Access Compliance Report

Public Rights-of-Way

(Pedestrian Signals)

Intersection ID: N/A	Main Street:	Cross Street: N/A	Location: N/A
ADA ID: 1BE13047534C	Signal Type: One Push Button-Non APS	Overall Compliance: No	Severity Score: BTN 1: N/A BTN 2: N/A No BTN: N/A
Codes/Mitigation Info/Possible Solution		Field Measurements/Component Compliance

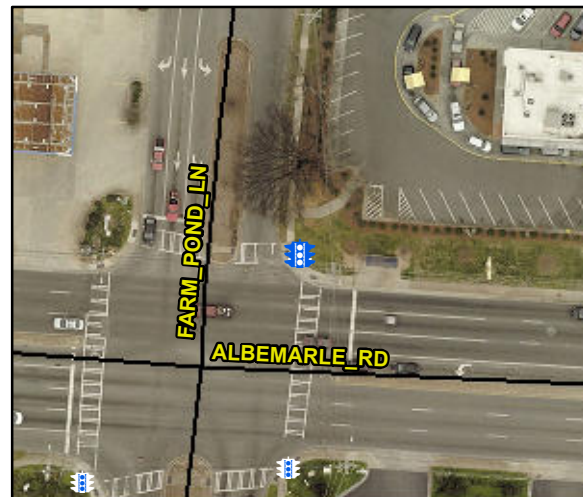
Surveyor Notes: TEXT HT 7/16

PROW/ADA: R410.6, R209.1, TMUTCD 4e.08, R404.2, R404.3, R406.2

Possible Solutions: Replace Signal Push Button With APS Button on New Post. Remove & Replace Sign.
